**5-E-21-HZ**  
**APPLICATION FOR CERTIFICATE OF APPROPRIATENESS**

**207 S. Seventeenth St. 37916**  
**Ft. Sanders NC**

Original Print Date: 5/5/2021  
 Knoxville/Knox County Planning -- Historic Zoning Commission

# DESIGN REVIEW REQUEST

1 Seventeenth Street (East) Elevation  
 1/4" = 1'-0"

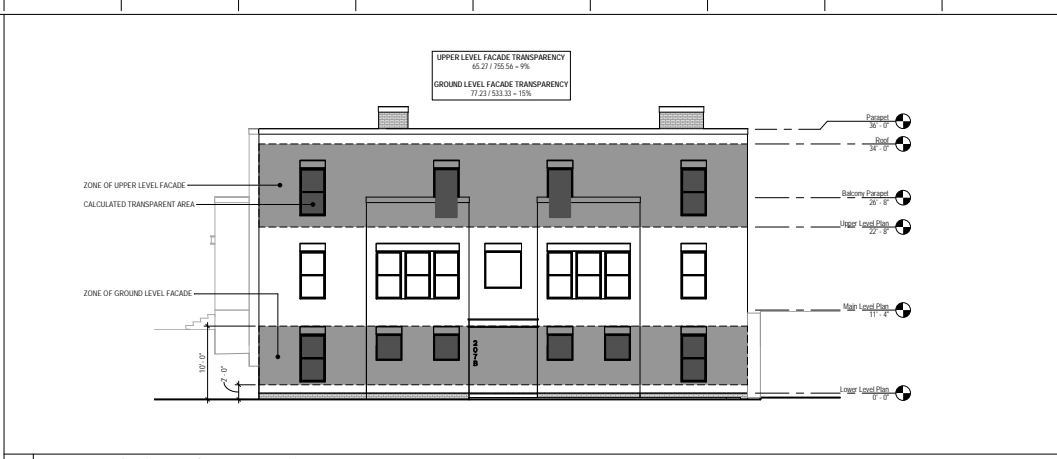
2. The L-shaped massing is a creative solution to working within the existing C-G-2 zoning, the site's topography, 10' easements on the north, east, and west property lines, and to "hide" the parking area from view from Forest Avenue and S. 17th Street. Though the L-shaped design does create two longer massings along both 17th and Forest, the massings are broken up by the projecting one- and two- story balcony sections. The 17'-4" section which serves as the corner massing (side of Unit A on the site plan, rightmost side of the S. 17th Street elevation) needs additional transparency to break up a solid massing (one window on each story to match existing, accent windows, or material change or additional detail could be options).

- 1) Granting of all necessary variances at 5/18/21 Board of Zoning Appeals meeting;
- 2) Break up large massing with no transparency on rightmost side of S. 17th Street elevation (using three stories of double-hung windows to match, material change, or other visual element);
- 3) On the Forest Avenue elevation, use doors to match design and placement of those on S. 17 Street instead of perpendicular to façade;
- 4) Parking to meet City Engineering requirements;
- 5) If possible, retaining wall along Forest Avenue to be retained or re-constructed using materials to meet design guidelines;

1 Forest Avenue (North) Elevation  
 1/4" = 1'-0"

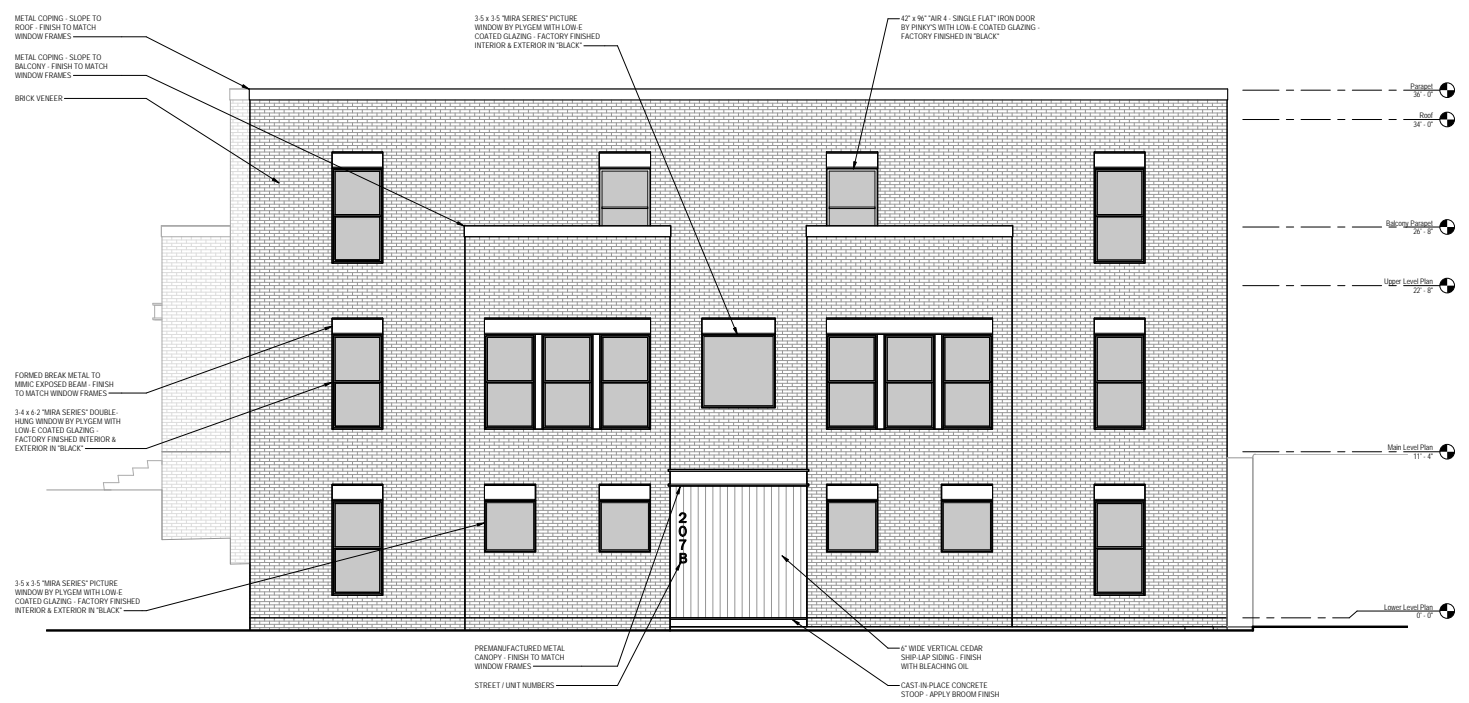
2. Guidelines recommend selecting a porch with proportions and materials that complement pre-1940 housing, measuring between 6' and 10' deep. The applicant has selected an entry stoop which is recessed between the two broader projecting sections; the entry stoops are approximately 5' deep and 9'-4" wide. Balconies are located above the projecting massings. While the entry stoops will be somewhat less narrow than the recommended front porches, the intended effect of a front porch is supported by material change, the proposed doors' transparency, and the upper-level balconies. The deviation from the guidelines is appropriate in this case. On the Forest Avenue elevation, using double doors that match the other entryway instead of a perpendicular door would contribute to the front porch effect.

5. Guidelines recommend that proportions of upper-level windows should not exceed first-story windows. The Commission may choose to discuss this guideline with relation to the Forest Avenue elevation and the smaller, single-light picture windows on the first story. Adding street-facing doors on this elevation would contribute to the overall transparency.
